SCHEDULE OF AMENDMENTS:

28 Lockwood avenue,
 BELROSE
 NSW 2085

DATE	MAR 2024	NORTH
DRAWN	JS	CHECK NL
SCALE	1:200 @A1 Sheet Size	
DWG NO.	DA-106	ISSUE 4
STATUS	ISSUE FOR SECTION 4.55	JOB NO.

Level 01 plan

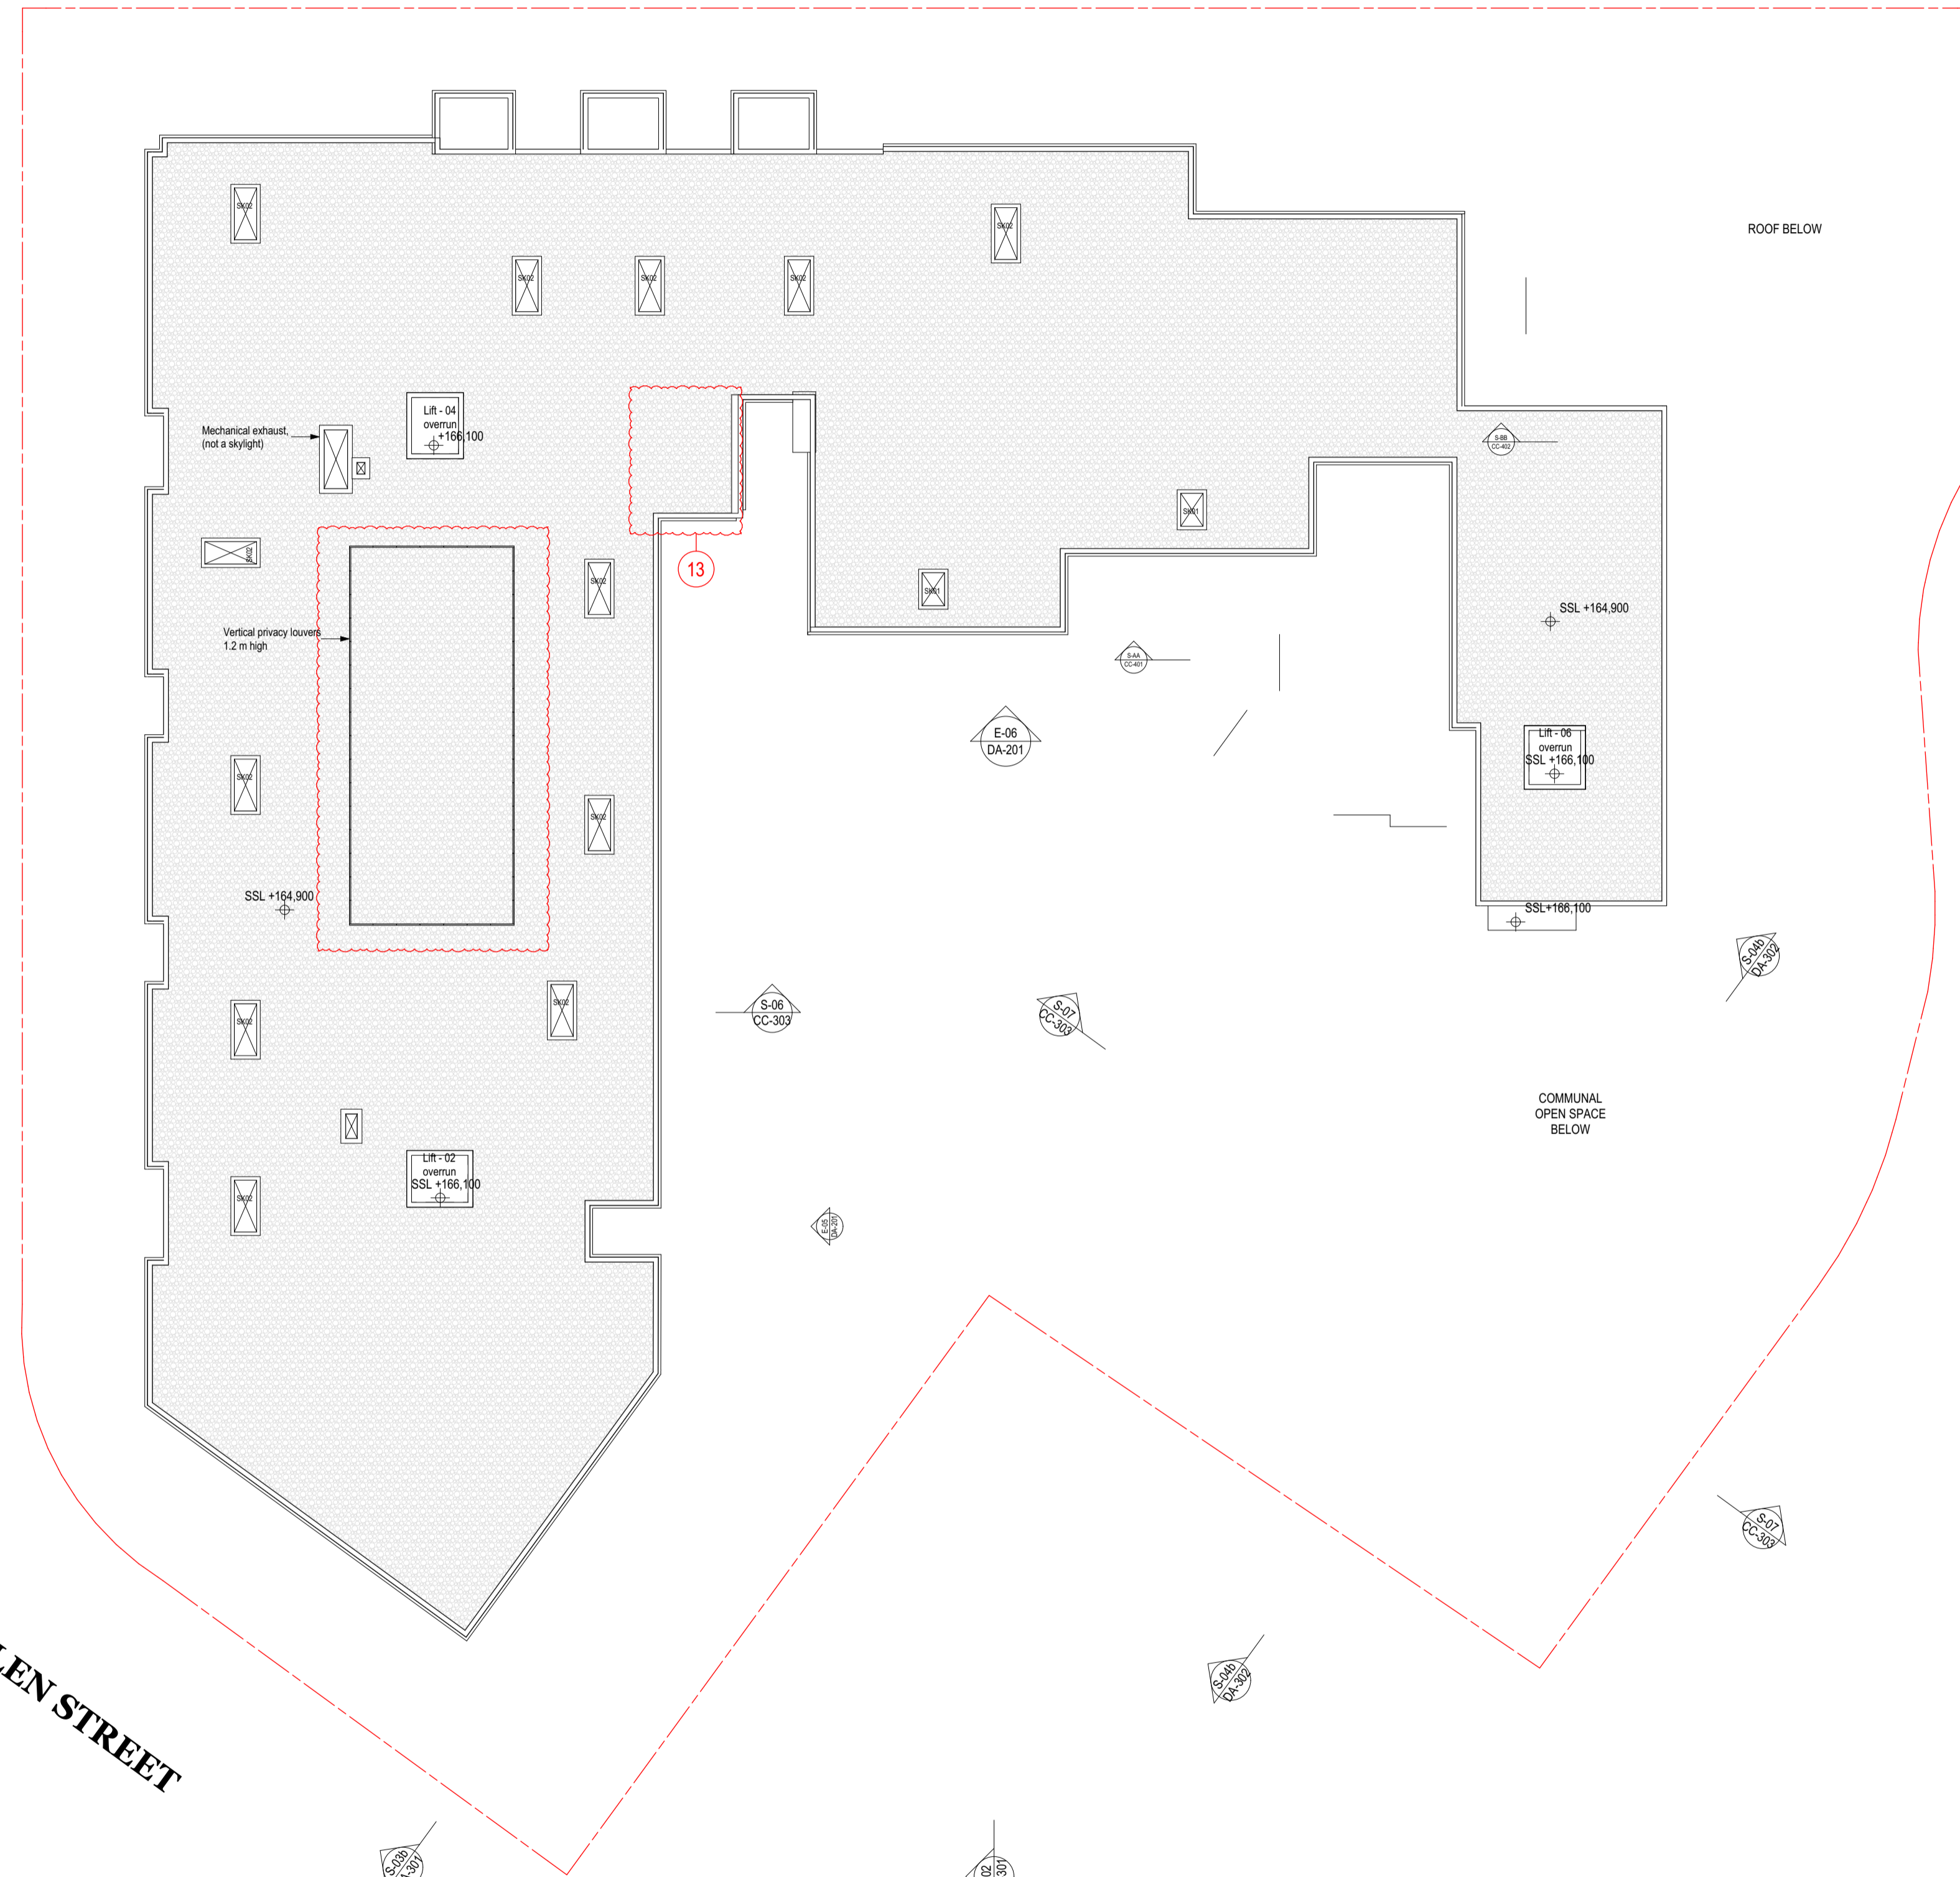
- 9- Unit LG01: The external wall of the living room has been pushed out 500 mm to improve the internal layout of the unit.
- 10- Unit 1.12: The external north facing wall has been pushed out 2300 mm to improve the internal layout of the unit and its area has increased by 18.6 m².

- 13- The roof is extended over the new extension of unit L1.04.
- 14- Unit L1.11: internal amendments to floor plan to avoid drainage of bathrooms inside lift 01 overrun below.

DRAWING
 Roof plan

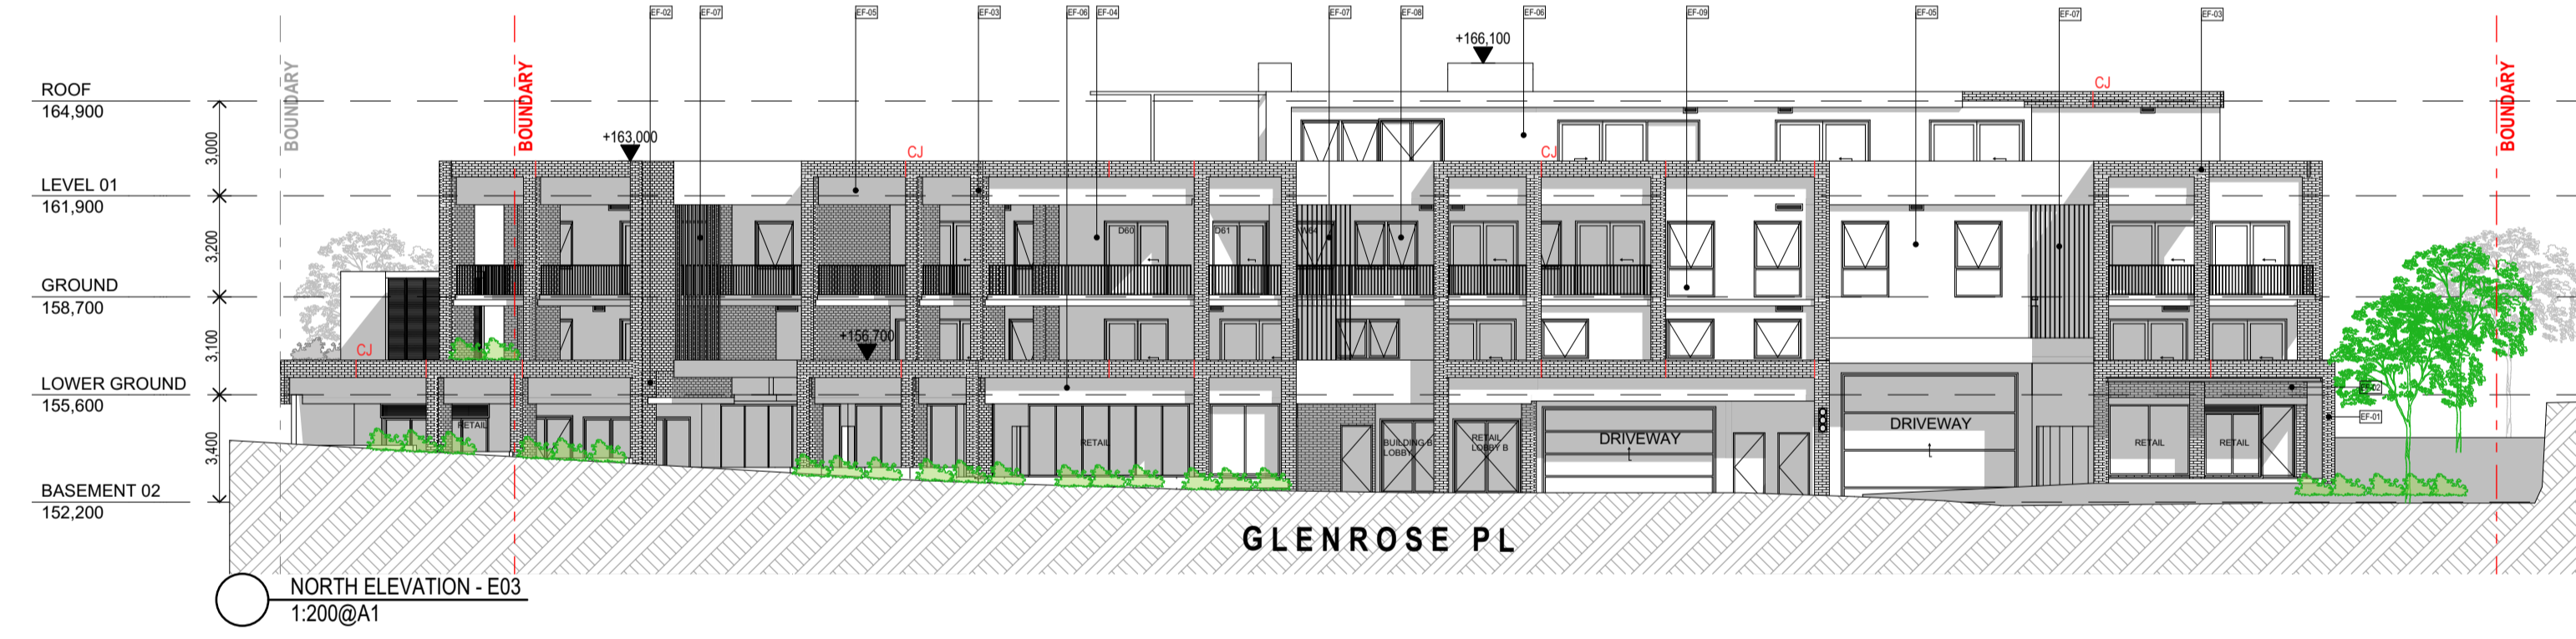
- 13- The roof is extended over the new extension of unit L1.04.
- 14- Unit L1.11: internal amendments to floor plan to avoid drainage of bathrooms inside lift 01 overrun below.

DRAWING
SECTIONS

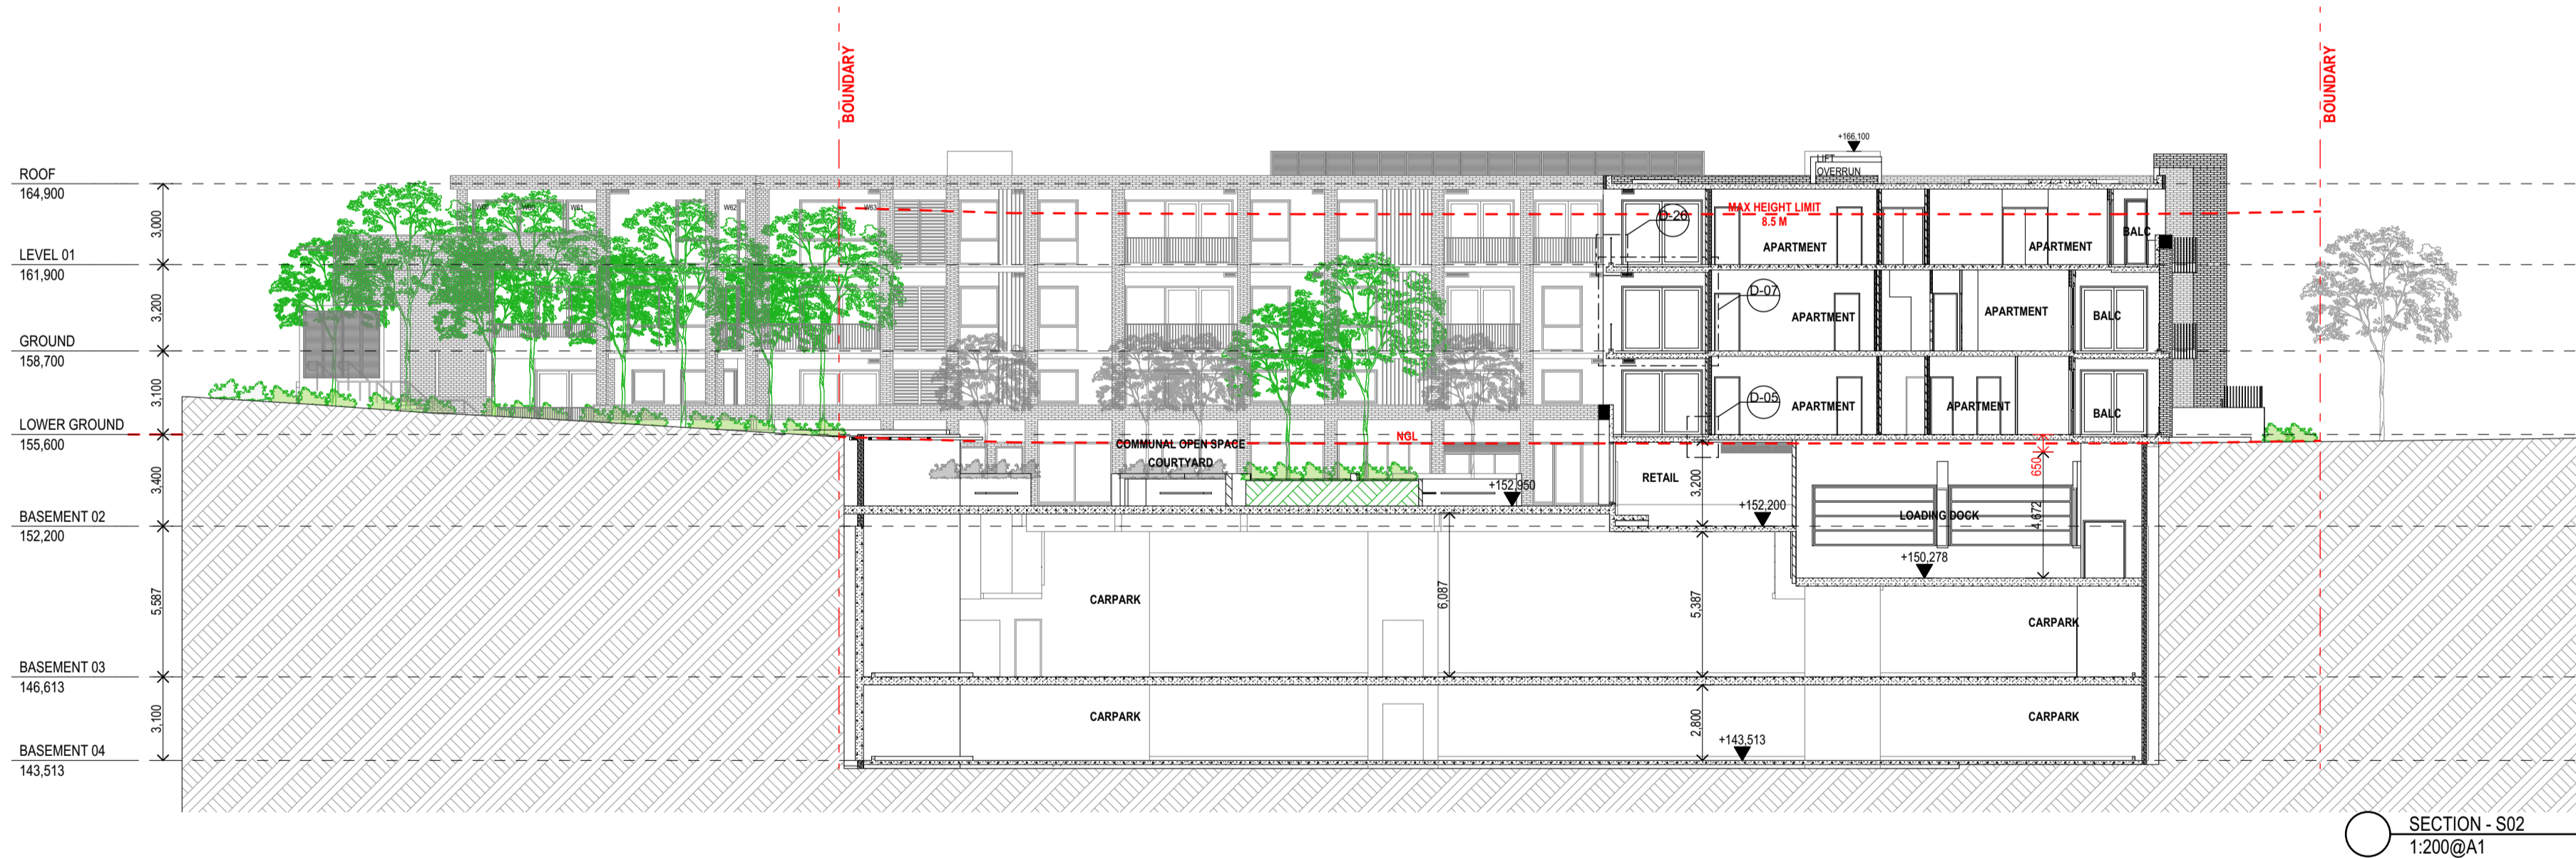
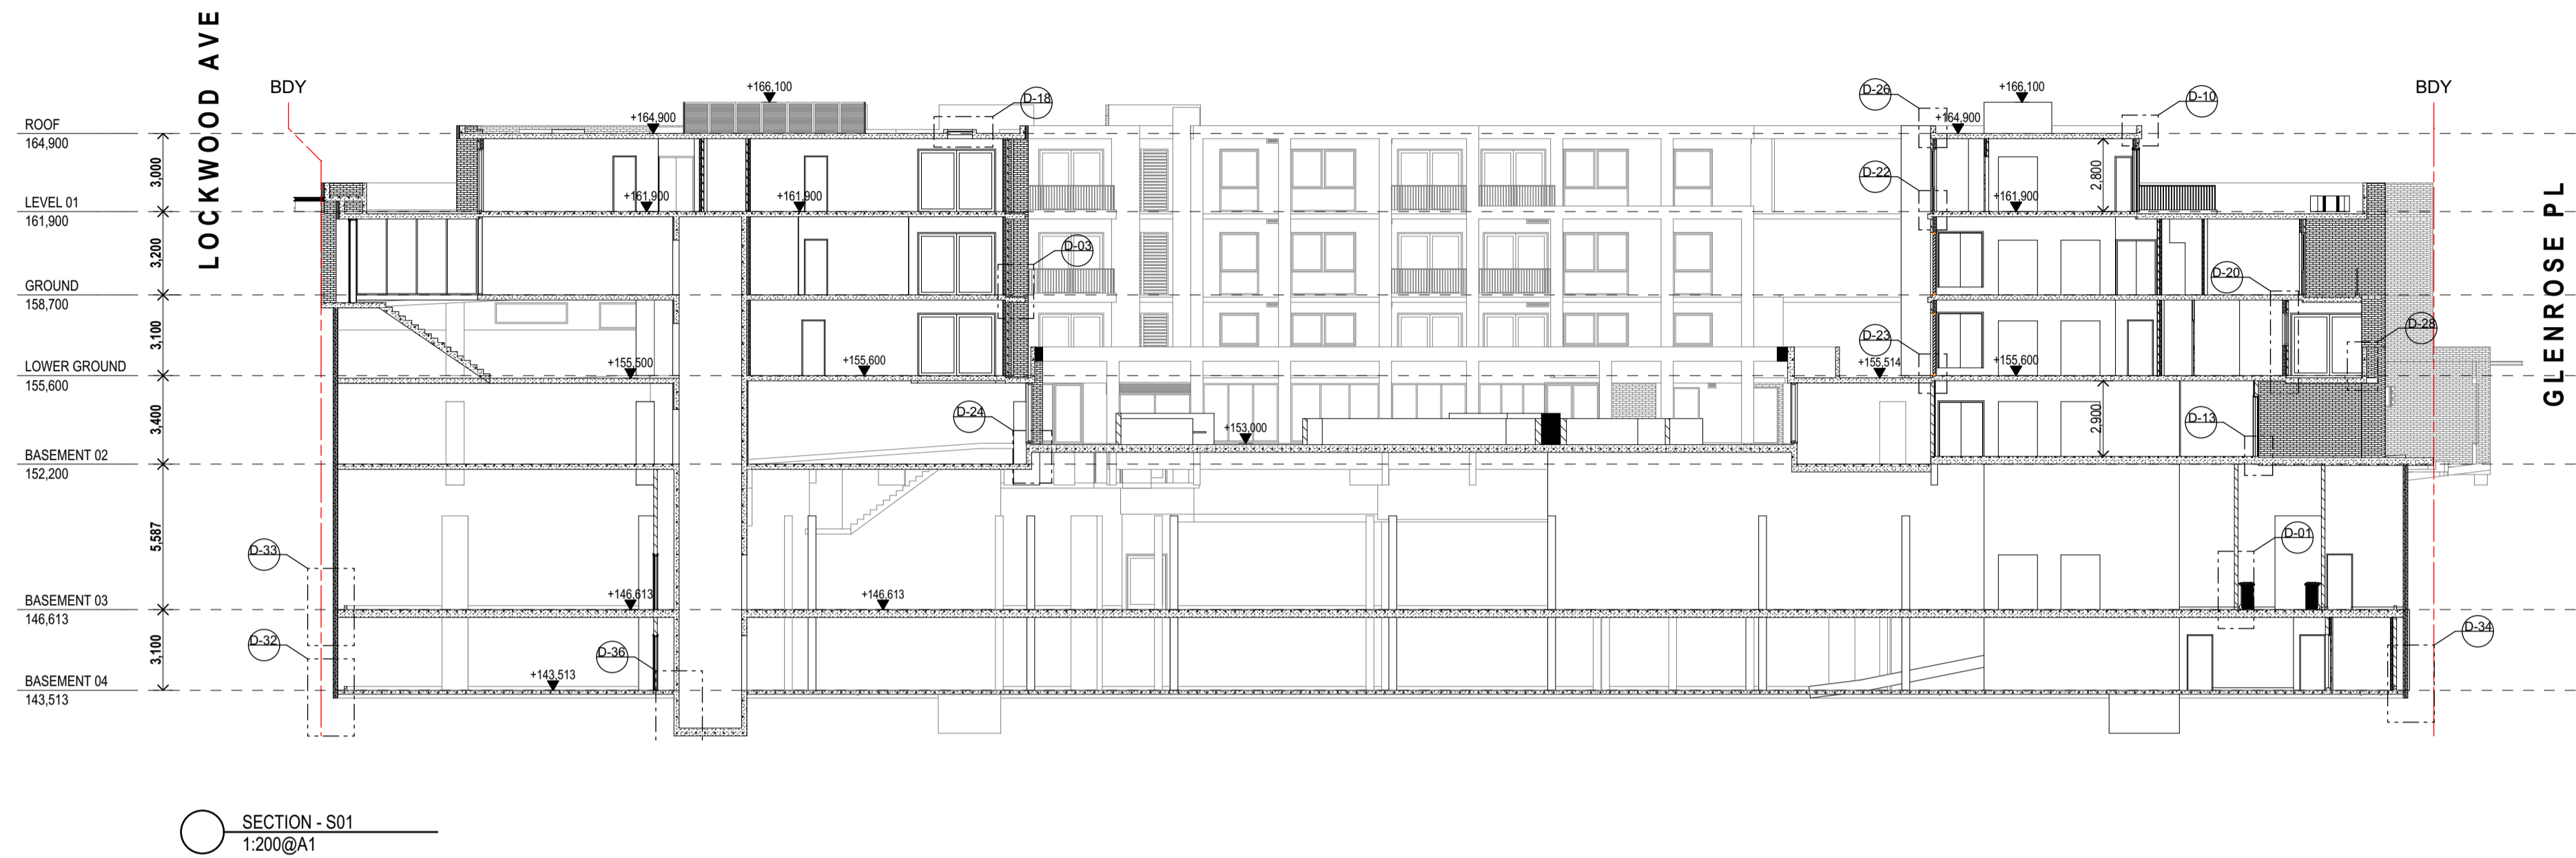
- 1- (Deleted).
- 2- EF-04, EF-05 & EF-06: the "painted concrete" is replaced with "render paint" as specified in the legend of the schedule of finishes.
